RS-24-081

Braidwood Station, Units 1 and 2
Renewed Facility Operating License Nos. NPF-72 and NPF-77
NRC Docket Nos. STN 50-456 and STN 50-457

Subject: Application to Incorporate a Diurnal Curve to Braidwood Station Technical Specifications 3.7.9 for the Ultimate Heat Sink

TS Figure 3.7.9-1 (page 1 of 1)
Temperature of Average Water Temperature of UHS Versus Time of Day Requirements

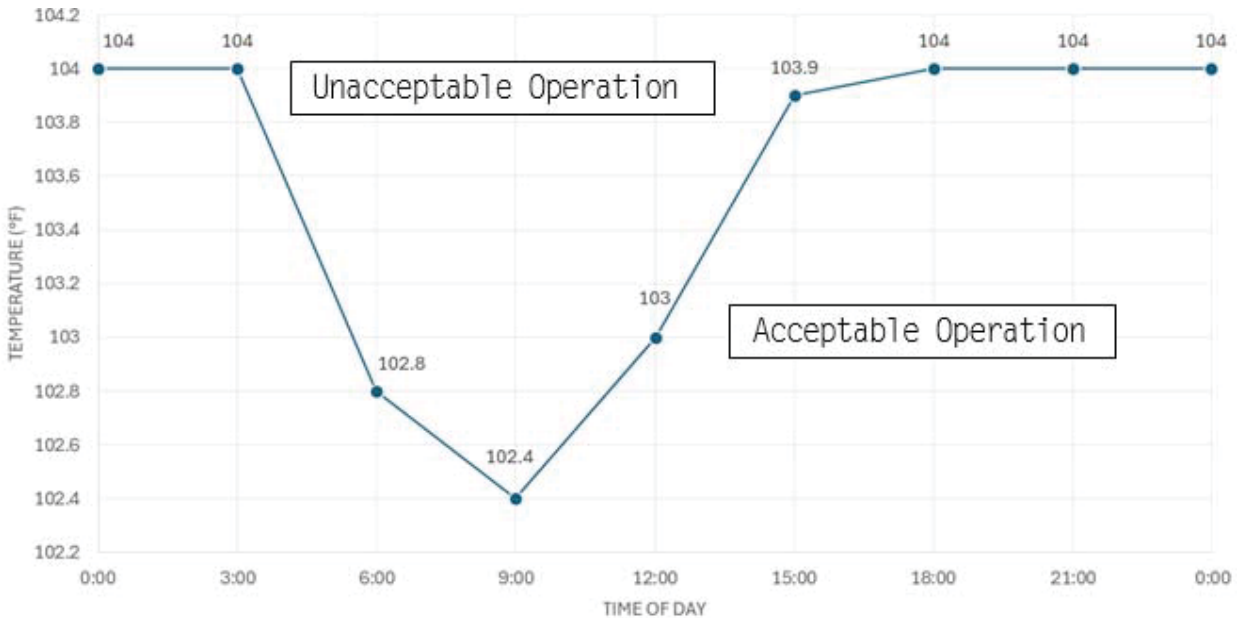
The proposed change revises SR 3.7.9.2 to replace the verification of the current single average water temperature limit with a temperature versus time-of-day graph that is based on the UHS temperature diurnal cycle. The temperature versus time-of-day graph is incorporated as Figure 3.7.9-1 to the TS and is referenced by SR 3.7.9.2. Additionally, the proposed change increases the Frequency of SR 3.7.9.2 from 24 hours (Surveillance Frequency Control Program) to every hour when the UHS average temperature is greater than or equal to 100°F.

TS 3.7.9 Conditions are not altered by the proposed changes. If the average water temperature of the UHS exceeds the limits of proposed TS Figure 3.7.9-1, Condition A must be entered immediately. TS 3.7.9 Required Actions A.1 and A.2 would be entered concurrently, requiring entry into Mode 3 within 12 hours and entry into Mode 5 within 36 hours. Furthermore, the application of the TS does not change based on the TS SR 3.7.9 average water temperature limit (i.e. use of proposed diurnal curve or use of the existing single temperature value).

SR 3.7.9.2	Verify average water temperature of UHS is within the limits of Figure 3.7.9-1. $\leq 102.8^{\circ}\text{F}$ until September 30, 2024. After September 30, 2024, verify average water temperature of UHS is $\leq 102^{\circ}\text{F}$.	<p>Once per hour when average water temperature from UHS $\geq 100^{\circ}\text{F}$</p> <p>AND</p> <p>In accordance with the Surveillance Frequency Control Program</p>
------------	---	--

**Figure 1
3-SX Pump Cases – Maximum Diurnal Initial UHS Temperature Allowable**

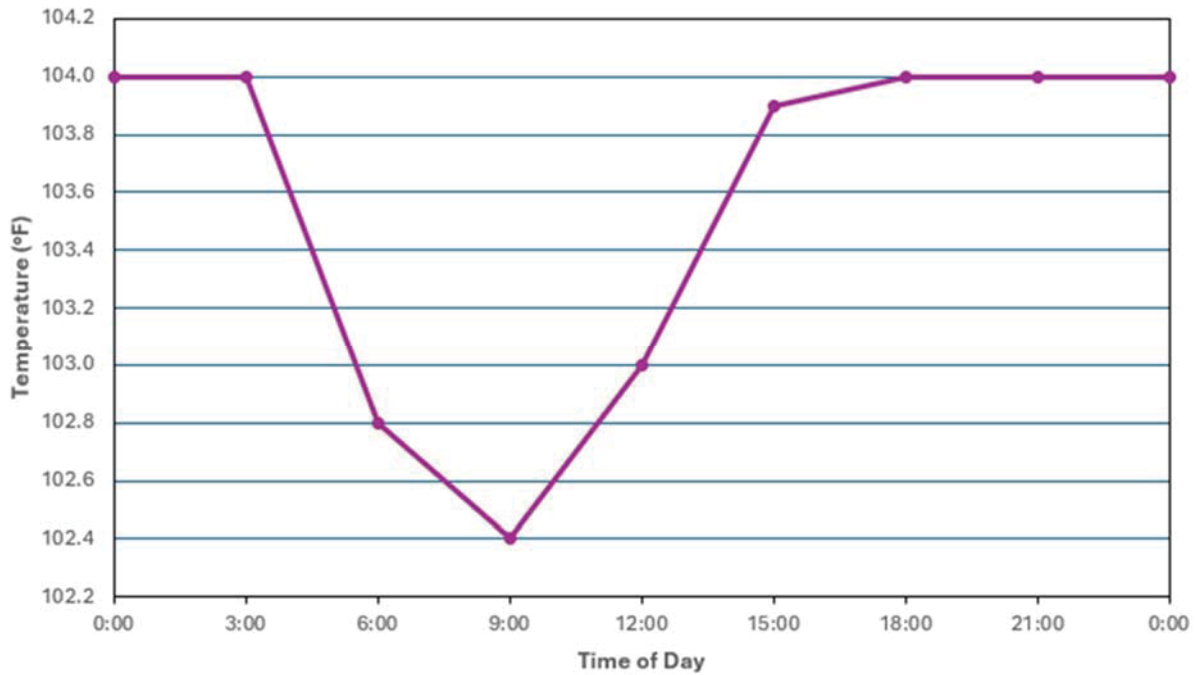
The new temperature limit curve (Figure 1) allows the UHS temperature to increase to a maximum of 104°F from hours 18:00 to 03:00 during normal plant operation. The increase of 2°F does not degrade the structural integrity of the materials used to construct the ESCP structure.

The results of the UHS temperature analyses are shown in Figure 1, which is the same figure being proposed for incorporation into the TS (i.e., Proposed Figure 3.7.9-1).

Figure 2
Maximum UHS Temperature – 3 SX Pumps – 33 Days

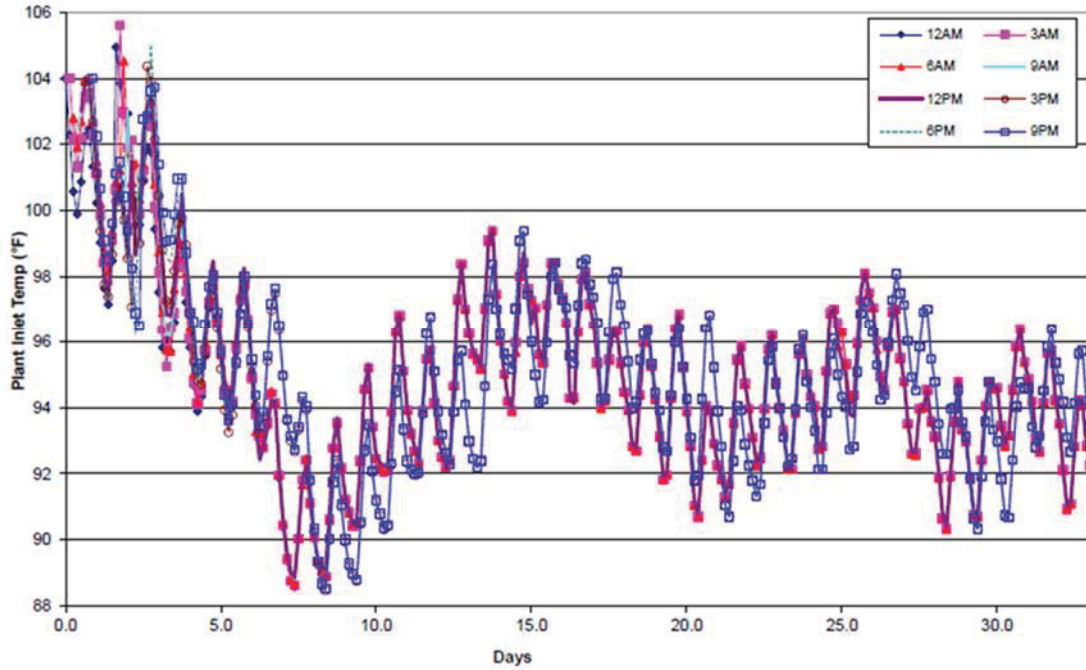
Figure 2 shows the UHS temperature response to a DBA LOCA for each of the start times, every 3 hours in a 24-hour period, for the 33 days period post-accident, and Figure 3 shows an expanded view of the same response for initial 3 day period. The maximum allowable temperature for each start time is the initial temperature in the graph for that start time.

Figure 3
Maximum UHS Temperature – 3 SX Pumps – 3 Days

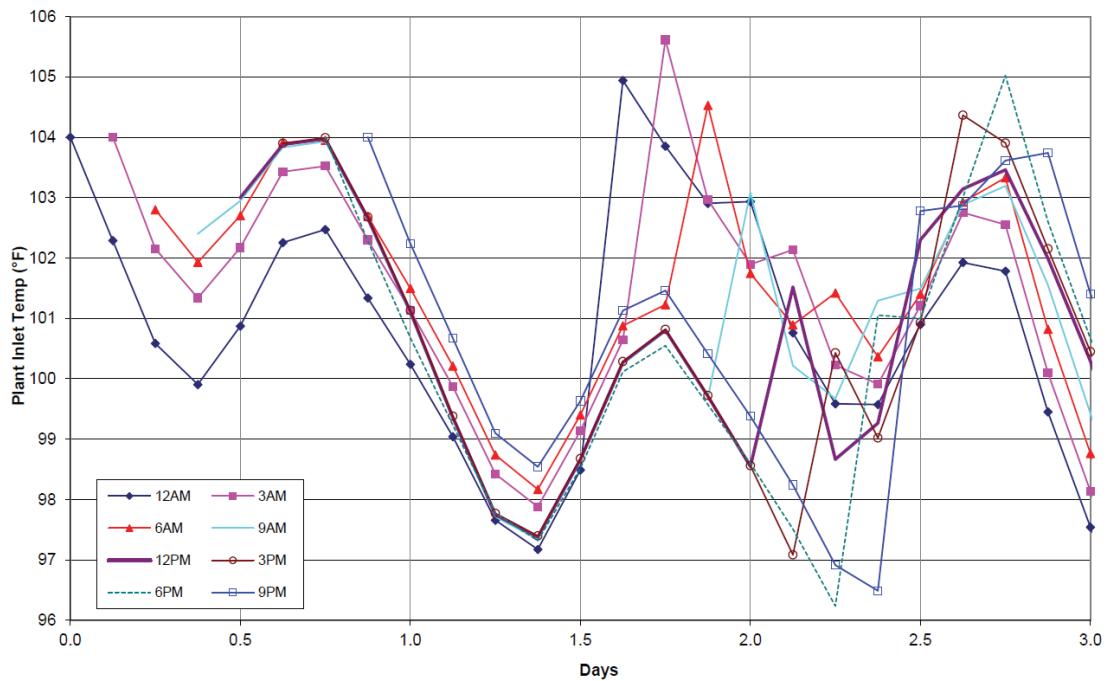
- The peak UHS temperature is 104°F or below in the 36 hours following the DBA, as seen in Figure 3. This is an input to the UFSAR Chapter 6 accident analyses that use the RCFCs for heat removal (LOCA Mass and Energy Release and Containment Integrity, Main Steam Line Break Mass and Energy Release and Containment Integrity). The Main Steam Line Break (MSLB) accident is not the limiting accident for the UHS.
- The peak UHS temperature for the 30-day period following the LOCA is $\leq 106^\circ\text{F}$.

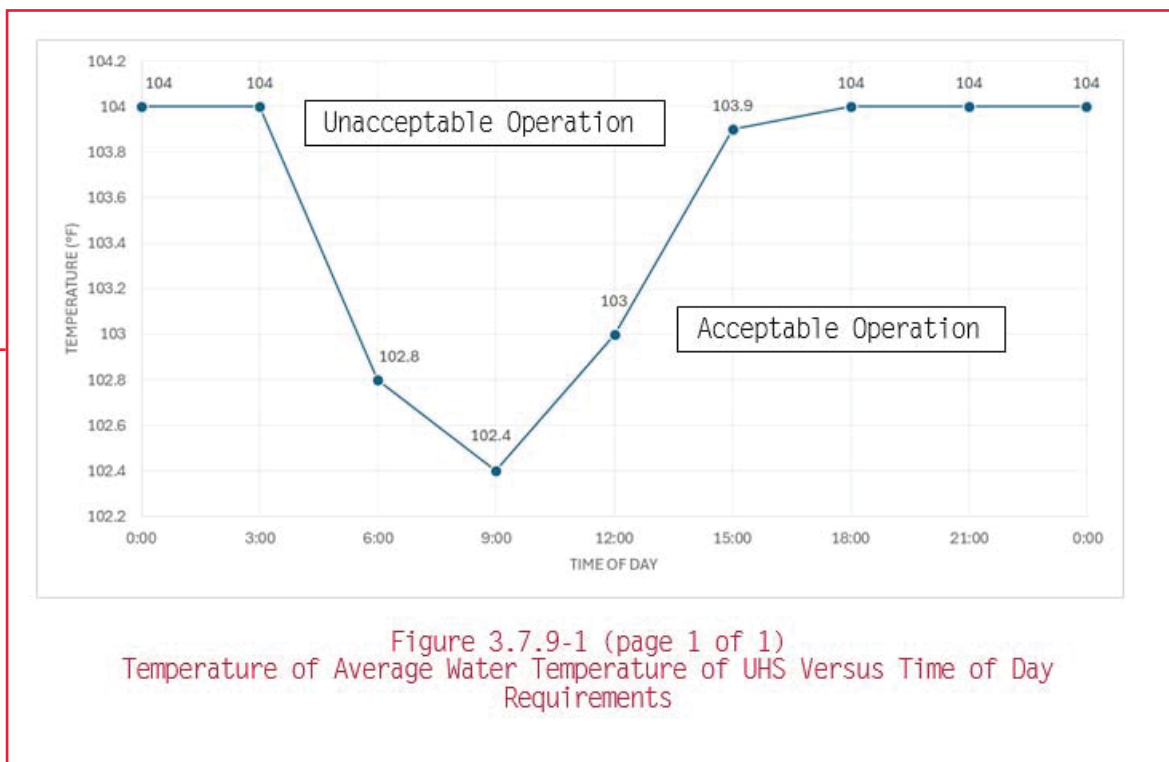
SURVEILLANCE	FREQUENCY
SR 3.7.9.1 Verify water level of UHS is ≥ 590 ft Mean Sea Level (MSL).	In accordance with the Surveillance Frequency Control Program
SR 3.7.9.2 Verify average water temperature of UHS is $\leq 102.8^{\circ}\text{F}$ until September 30, 2024. After September 30, 2024, verify average water temperature of UHS is $\leq 102^{\circ}\text{F}$.	In accordance with the Surveillance Frequency Control Program

within the limits of Figure 3.7.9-1.
